DOCUMENT CHANGE REQUEST

DCR number 442 Changes required for: General

Title: Transistors Low Power PNP, based on types 2N2894 and 2N2894A

Number: 5202/004

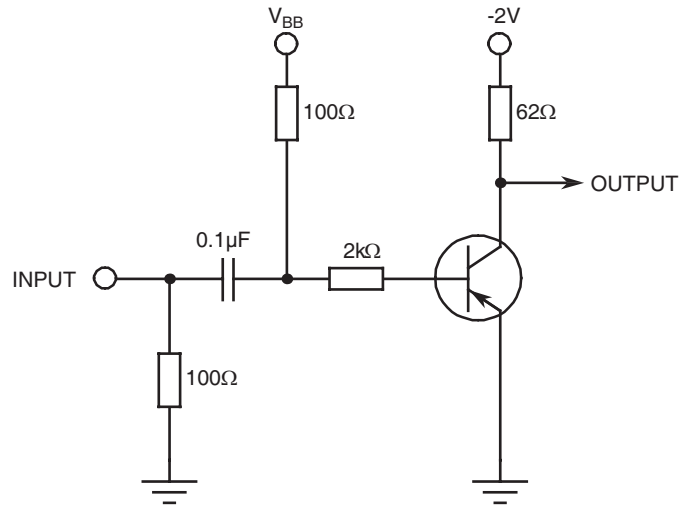
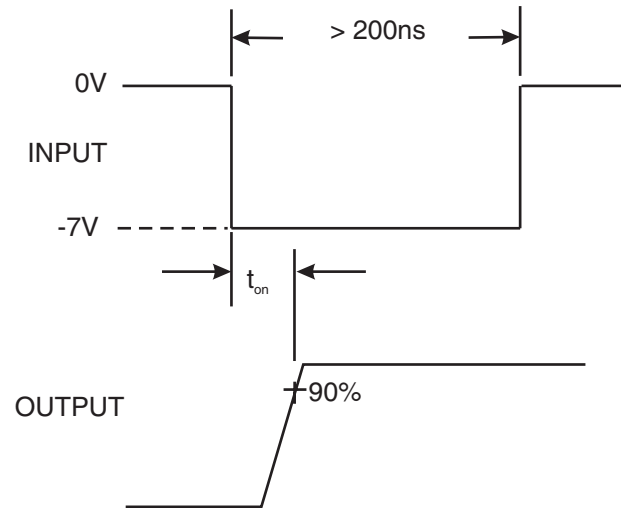
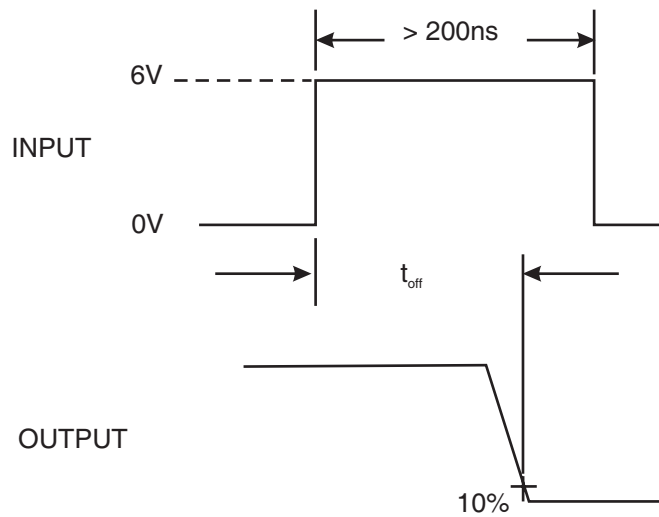
19. Table 2: Figure 4 deleted and incorporated in to a Note to Table 2 (Note 3).
20. Table 2: Replace LTPD7 sampling for AC parameters tests (designated by "Note 2") with an equivalent fixed sample of 32 components with 0 failures (or 100%).

1. Pulse measurement: Pulse Width $\leq 300\mu s$, Duty Cycle $\leq 2\%$
2. For AC characteristics read and record measurements shall be performed on a sample of 32 components with 0 failures allowed. Alternatively a 100% inspection may be performed.
3. t_{on} shall be measured using the following test circuit. The input waveform shall be supplied by a pulse generator with the following characteristics: $Z_{OUT} = 50\Omega$, $t_r \leq 2ns$, Pulse Width = $200 \pm 10ns$, Duty Cycle $\leq 2\%$. The output waveform shall be monitored on an oscilloscope with the following
